Our Ref: KC2225/MS

17th December 2021

**Proposed Development of Curraghinalt Mine
Response to NIEA letter of 18th November 2021; Ref: TC80/20, AIL/2020/0105, AIL/2020/0106**

Figure 1: Stages of Water Balance Test

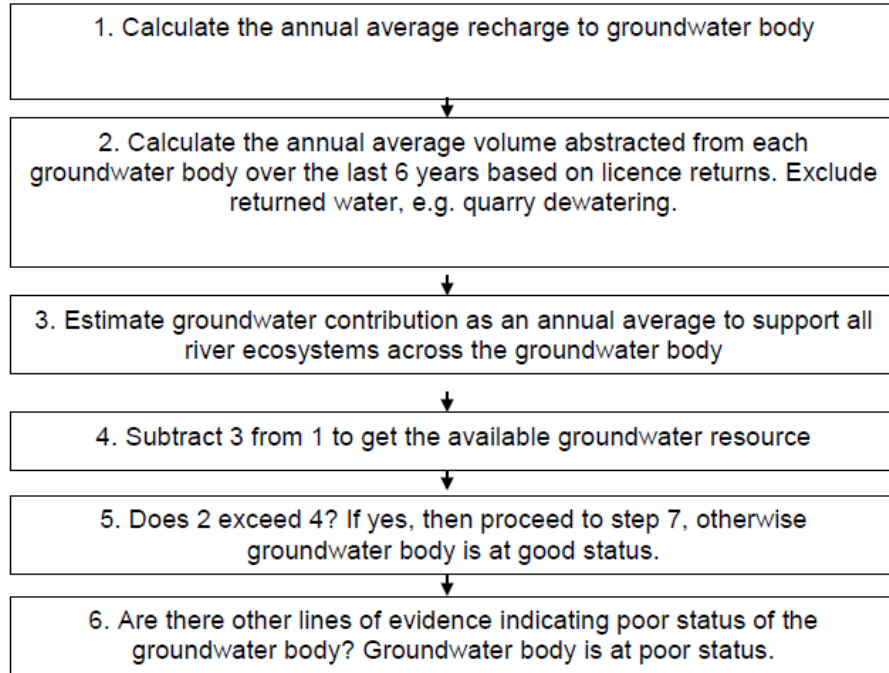
The NIEA letter specifically asks for '*supporting information to verify whether the proposed abstraction will impact the status of the groundwater body based on the water balance test*'.

UKTAG guidance (para 4.4) states that *'Abstracted groundwater that has been locally returned to the aquifer or to a river should be discounted (for example, this may occur at a quarry/mine dewatering operation'*. The specific reference to mine dewatering is noted. This guidance is reinforced in the 2015 NIEA Methodology and Figure 1, where abstracted water that is returned (e.g., quarry dewatering) is excluded from the calculation.

Therefore, following UKTAG and NIEA guidance the proposed abstractions are excluded from the Water Balance Test. As a result, given that the abstracted volume from the Gortin groundwater body would not be increased within the Water Balance Test calculation (Step 2 in Figure 1), there will be no impact on the status of the Gortin groundwater body as a result of the Water Balance Test.
